PCN – Process Change Notification

Change:	FW.90.SMA.M
Date:	2017/04/27
Author	Bonnie Chen

Model#	Part Number	Changes
FW.90 Penta-band Cellular Flexible Whip Antenna SMA(M) Straight	FW.90.SMA.M	1. Amend Package Rule.

Illustration of Change

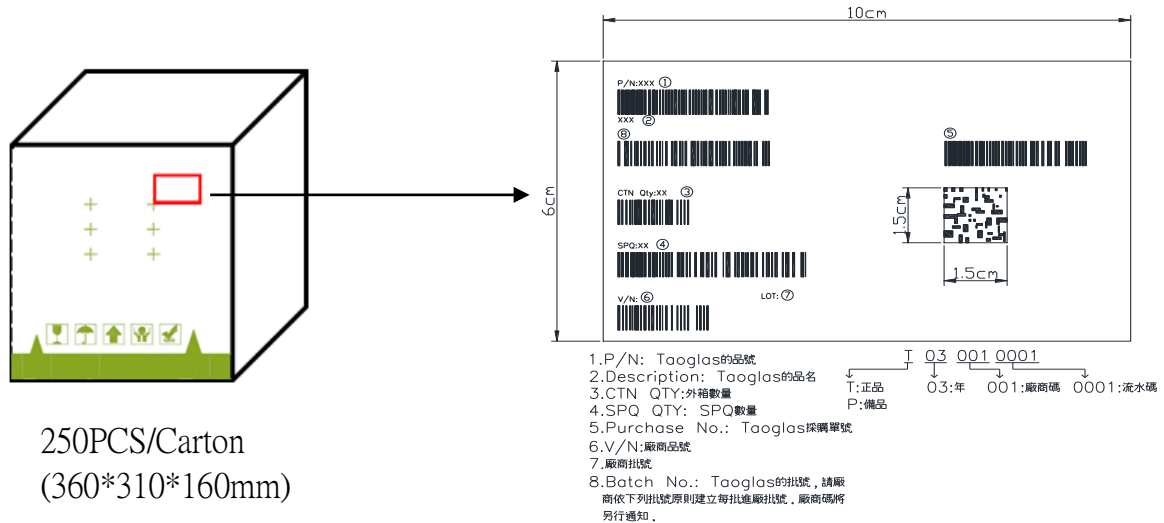
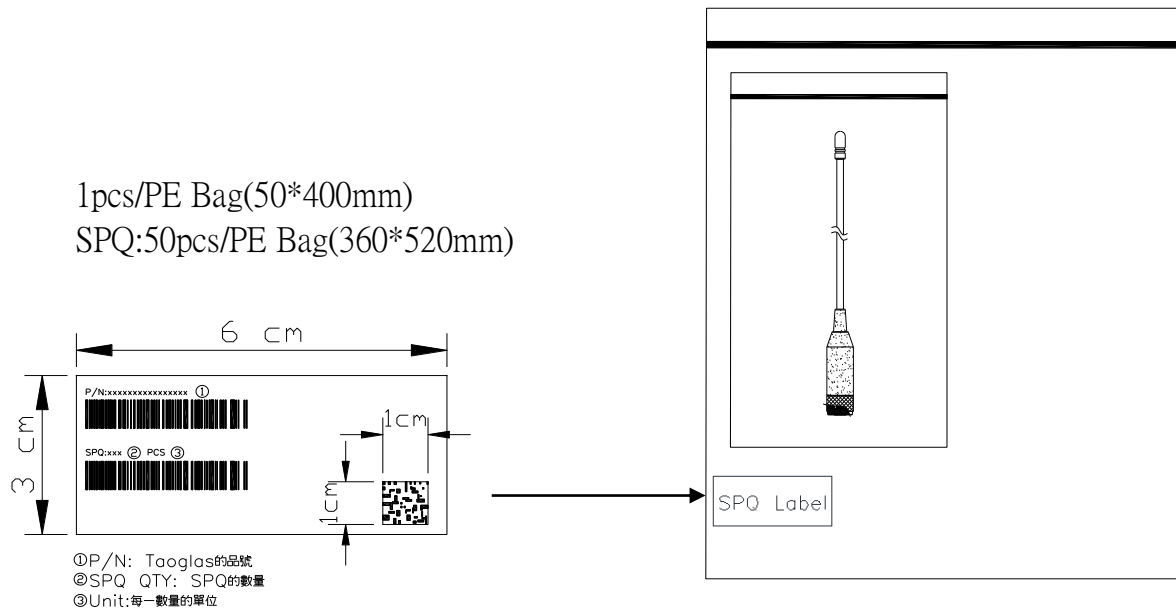
1. Amend Package Rule.

Old Package

New Package

1pcs/PE Bag(50*400mm)
 SPQ:50pcs/PE Bag(360*520mm)

200PCS/Carton
 (360*310*160mm)
